RECORD DRAWING

ONONDAGA COUNTY - DWEP
CLINTON CSO STORAGE FACILITY

ONONDAGA COUNTY • DEPARTMENT OF WATER ENVIRONMENT PROTECTION
 CLINTON CSO STORAGE FACILITY PROJECT

EAST CHAMBER
LOWER AND INTERMEDIATE PLANS
STRUCTURAL

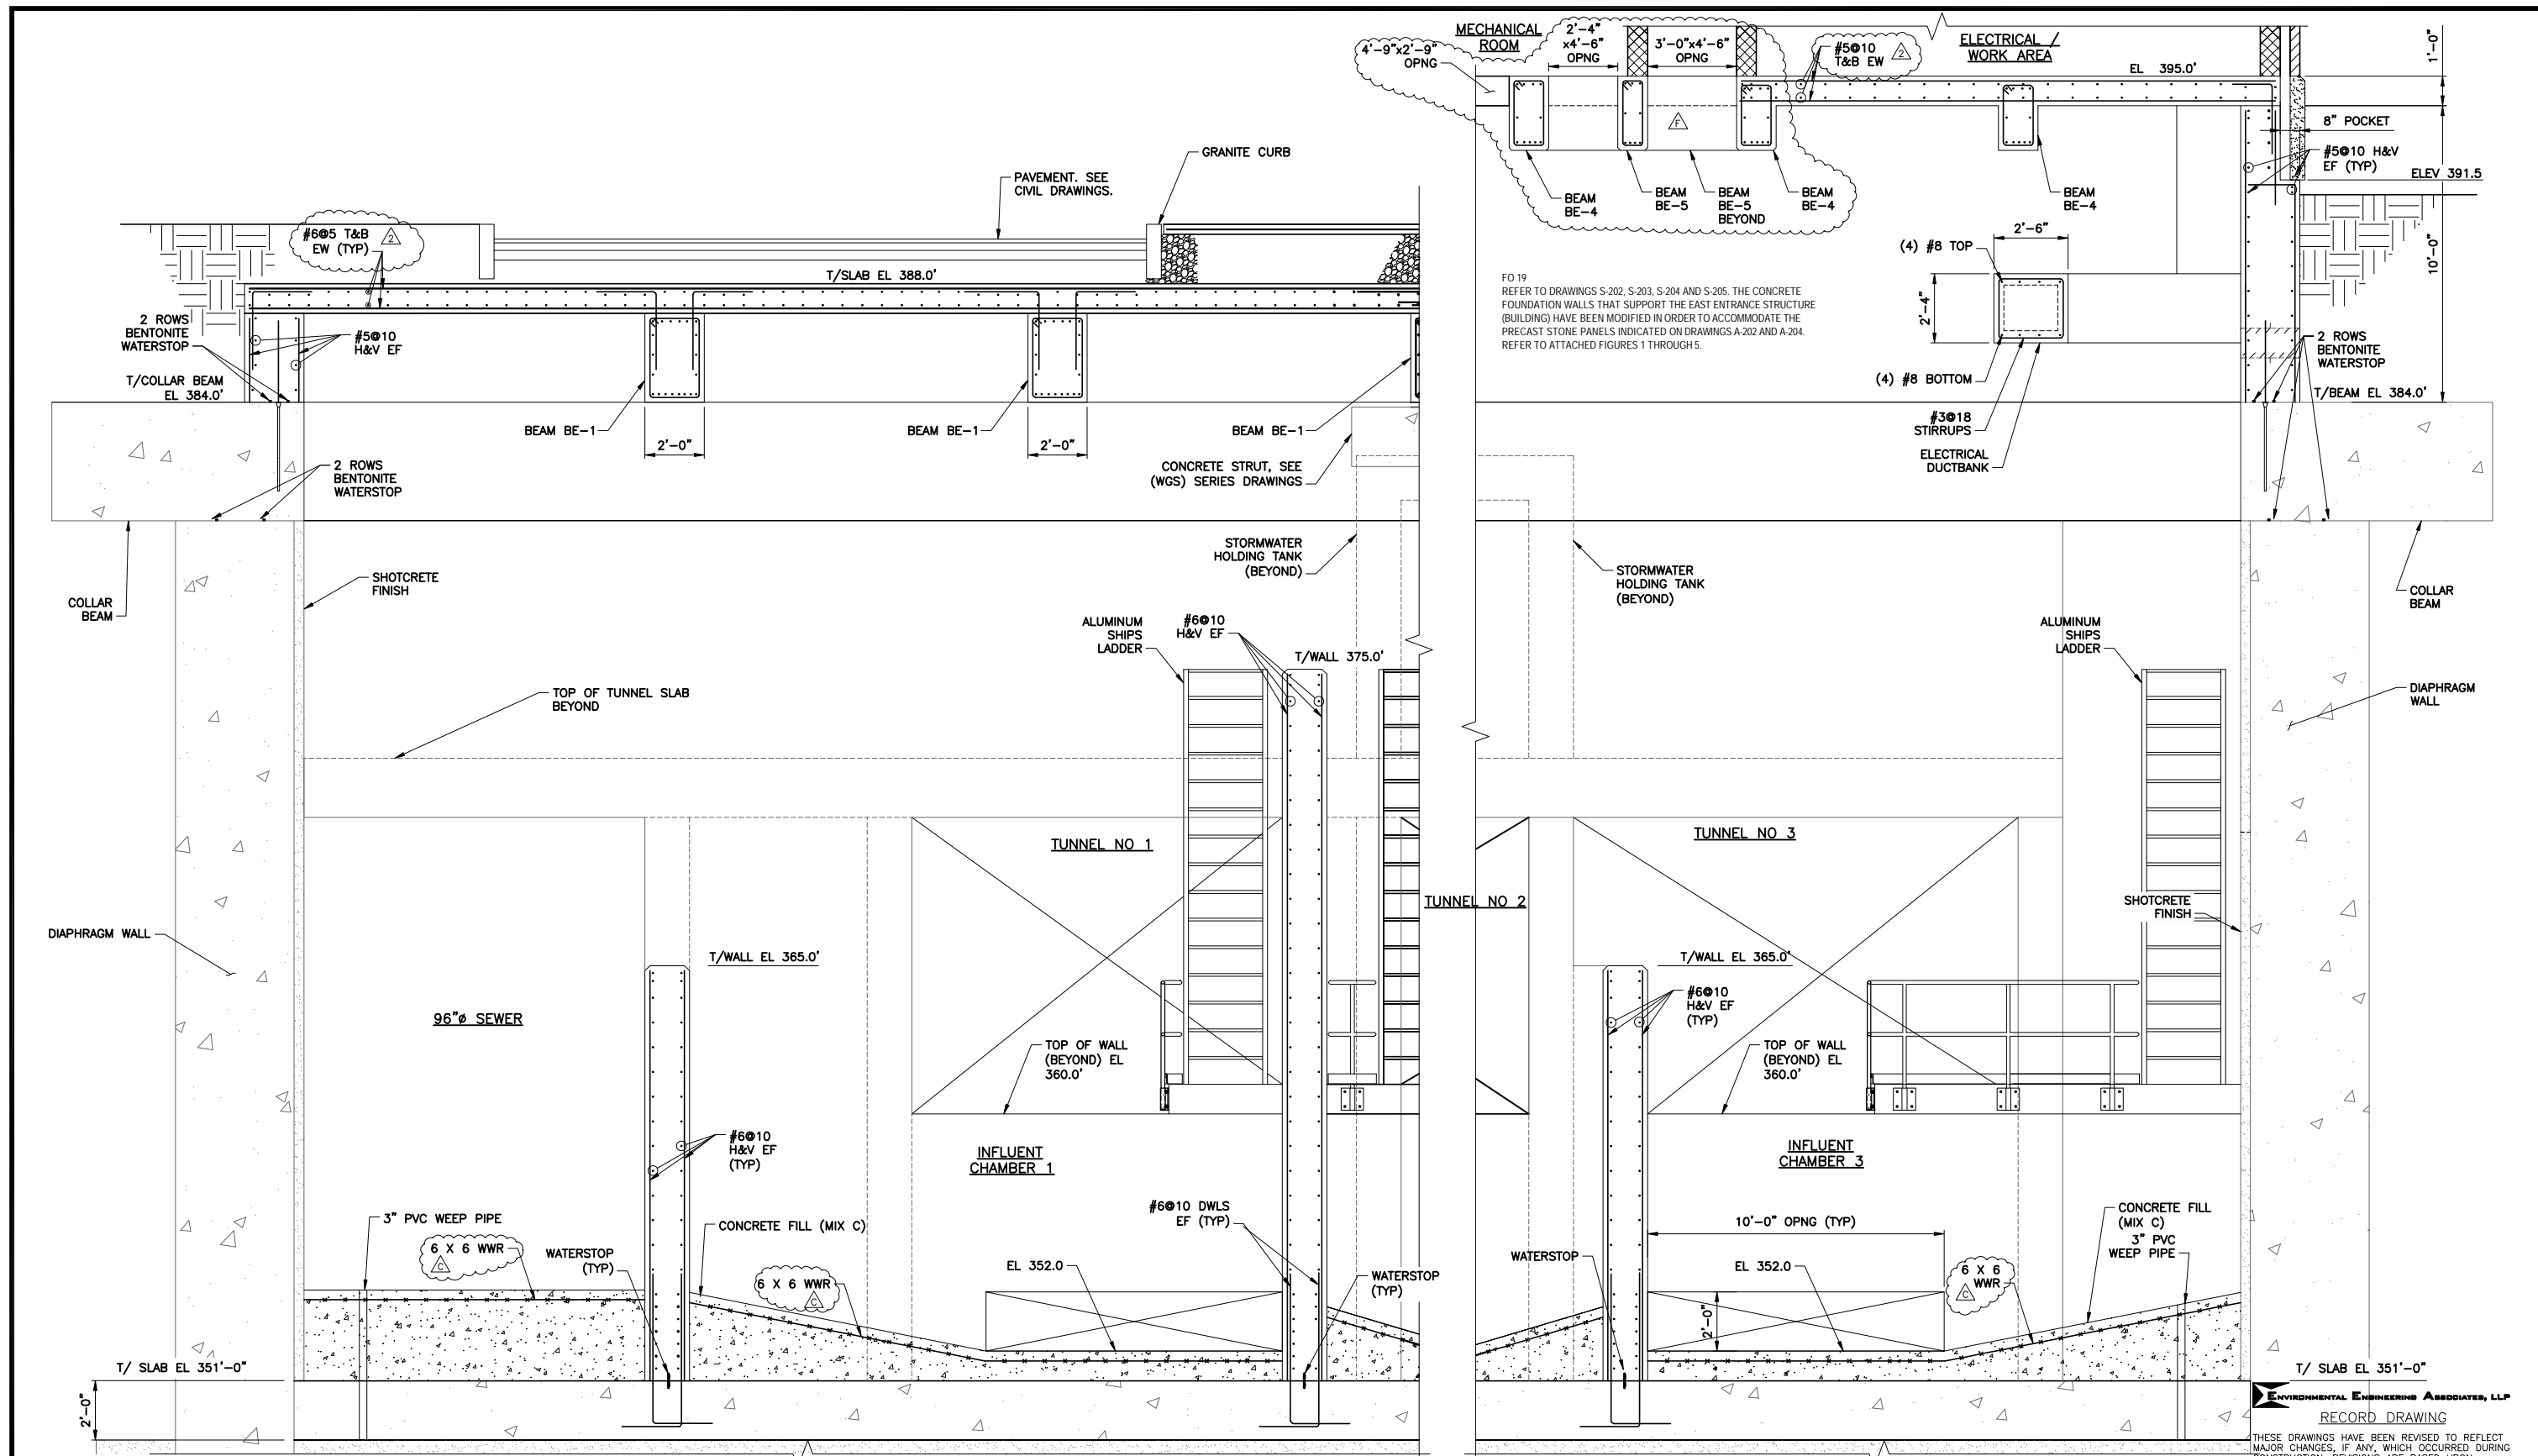
F08
LADDERS AT THE EAST END OF TUNNELS NO. 1, 2 & 3 SHOULD NOT EXTEND TO THE TUNNEL INVERT AND SHOULD BE TERMINATED 10 INCHES ABOVE THE FLOOR TO MINIMIZE HANG-UP OF MATERIAL DURING TUNNEL FLUSHING. THESE LADDERS ARE REFERENCED ON SHEET S-201, SECTION 4 SHEET S-204 AND SECTION S-205.

RFI 164
IT IS ACCEPTABLE TO INSTALL RETROFIT WATERSTOP TO INTERCONNECT THE EMBEDDED WATERSTOPS AT THE BASE OF WALLS IN THE TUNNEL TRANSITION DIVIDING WALLS AND EAST CHAMBER DIVIDING WALLS. NOTE THAT EMBEDDED WATERSTOP SHOULD HAVE ALSO BEEN CAST BELOW TO FLUSHING GATE OPENINGS. IF IT WASNT, THEN RETROFIT WAERSTOP SHALL BE INSTALLED AT THESE LOCATIONS AS WELLS.

FO 19
REFER TO DRAWINGS S-202, S-203, S-204 AND S-205. THE CONCRETE FOUNDATION WALLS THAT SUPPORT THE EAST ENTRANCE STRUCTURE (BUILDING) HAVE BEEN MODIFIED IN ORDER TO ACCOMMODATE THE PRECAST STONE PANELS INDICATED ON DRAWINGS A-202 AND A-204. REFER TO THE ATTACHED FIGURES 1 THROUGH 5.

RFI 246
BEAMS BE-1 & BE-2 SHALL 24"x36"; 24"x38" AS INDICATED IN THE BEAM SCHEDULE ON CONTRACT DRAWING S-202.

RFI 250
IT WAS INTENDED TO HAVE ONE 1-1/2" DIAMETER PVC SLEEVE CAST-IN PLACE AT EACH OF THE FOUR CORNERS OF THE REMOVABLE SLAB SECTION; SET 1 FOOT IN FROM THE EDGES OF THE SLAB. NOTE THAT A 1/2" ISOLATION JOINT IS TO REMAIN AROUND THE PERIMETER OF THE REMOVABLE SLAB SECTION (AS INDICATED IN THE PREVIOUS "NON-CONFORMED" CONTRACT DRAWINGS). THIS JOINT DOES NOT NEED TO CONTAIN FILLER MATERIAL, BUT SHALL BE FILLED WITH SEALANT.

**EAST CHAMBER
 FIRST FLOOR PLAN**
 STRUCTURAL

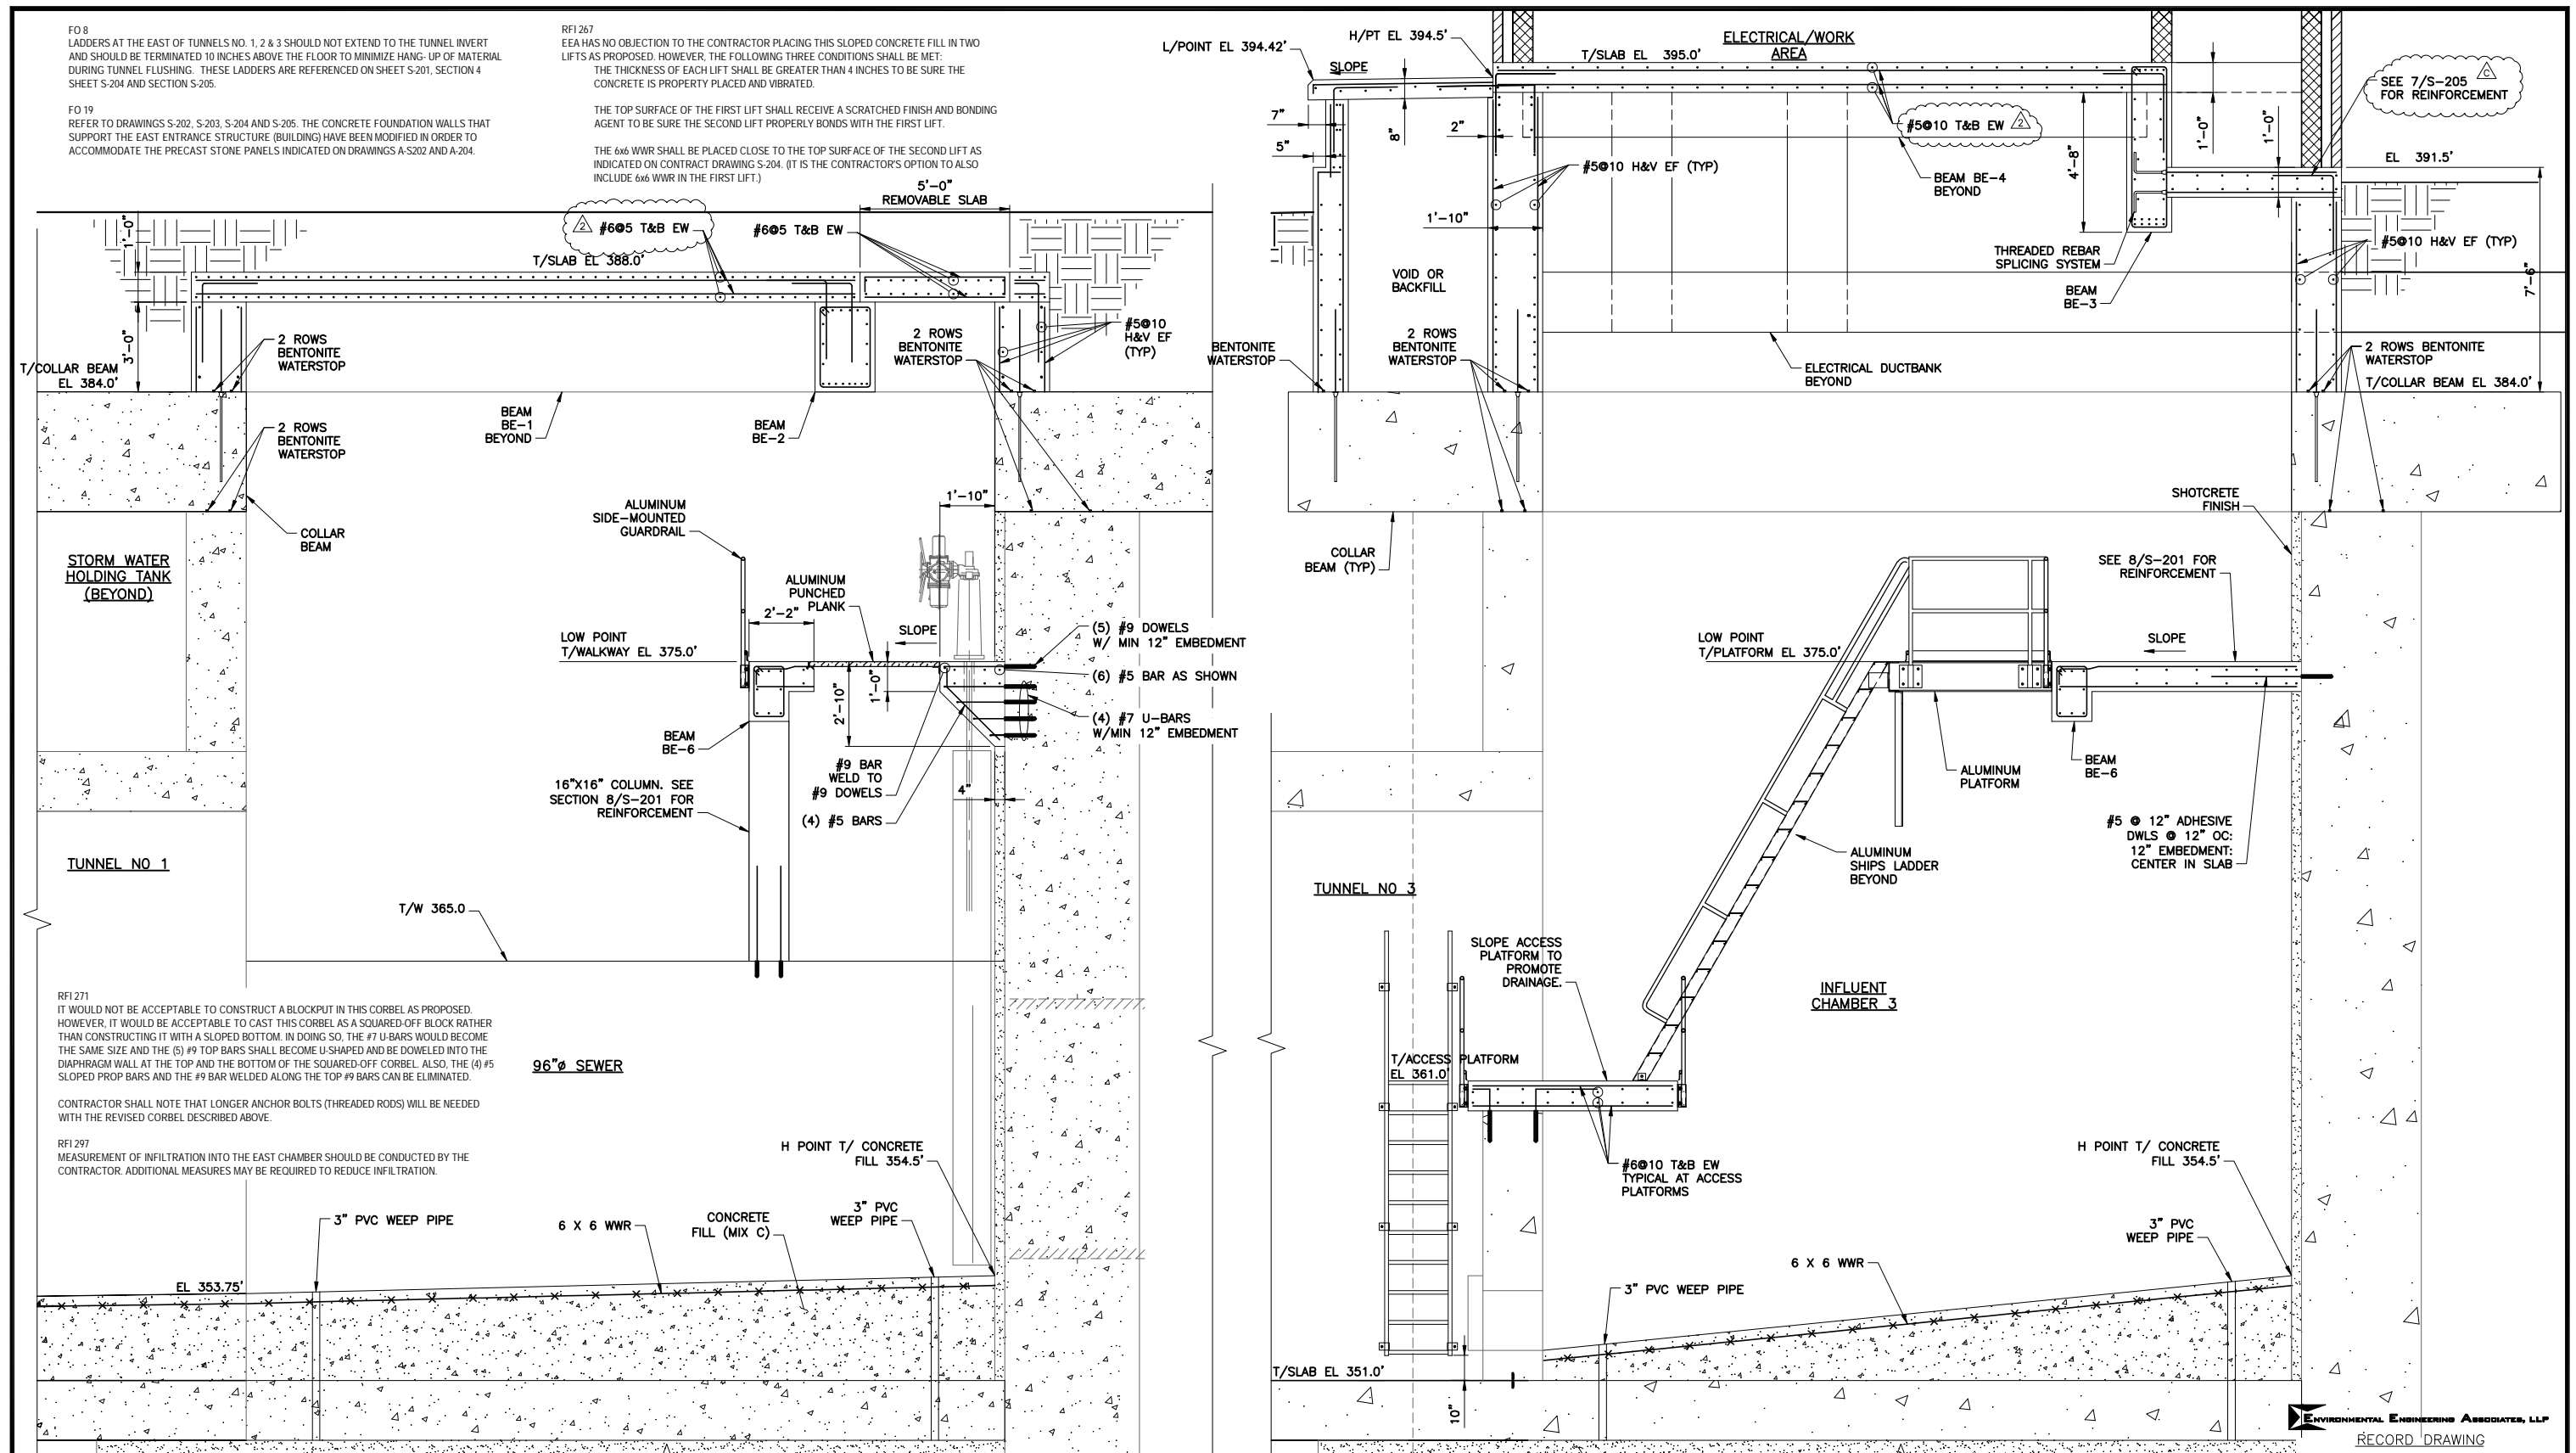
FD 19
 REFER TO DRAWINGS S-202, S-203, S-204 AND S-205. THE CONCRETE FOUNDATION WALLS THAT SUPPORT THE EAST ENTRANCE STRUCTURE (BUILDING) HAVE BEEN MODIFIED IN ORDER TO ACCOMMODATE THE PRECAST STONE PANELS INDICATED ON DRAWINGS A-202 AND A-204. REFER TO ATTACHED FIGURES 1 THROUGH 5.

FO 8
LADDERS AT THE EAST OF TUNNELS NO. 1, 2 & 3 SHOULD NOT EXTEND TO THE TUNNEL INVERT AND SHOULD BE TERMINATED 10 INCHES ABOVE THE FLOOR TO MINIMIZE HANG-UP OF MATERIAL DURING TUNNEL FLUSHING. THESE LADDERS ARE REFERENCED ON SHEET S-201, SECTION 4 SHEET S-204 AND SECTION S-205.

FO 19
REFER TO DRAWINGS S-202, S-203, S-204 AND S-205. THE CONCRETE FOUNDATION WALLS THAT SUPPORT THE EAST ENTRANCE STRUCTURE (BUILDING) HAVE BEEN MODIFIED IN ORDER TO ACCOMMODATE THE PRECAST STONE PANELS INDICATED ON DRAWINGS A-S202 AND A-204.

THE 6x6 WWR SHALL BE PLACED CLOSE TO THE TOP SURFACE OF THE SECOND LIFT AS INDICATED ON CONTRACT DRAWING S-204. (IT IS THE CONTRACTOR'S OPTION TO ALSO INCLUDE 6x6 WWR IN THE FIRST LIFT.)

CONTRACTOR SHALL NOTE THAT LONGER ANCHOR BOLTS (THREADED RODS) WILL BE NEEDED WITH THE REVISED CORBEL DESCRIBED ABOVE.

RF1297
MEASUREMENT OF INFILTRATION INTO THE EAST CHAMBER SHOULD BE CONDUCTED BY THE CONTRACTOR. ADDITIONAL MEASURES MAY BE REQUIRED TO REDUCE INFILTRATION.
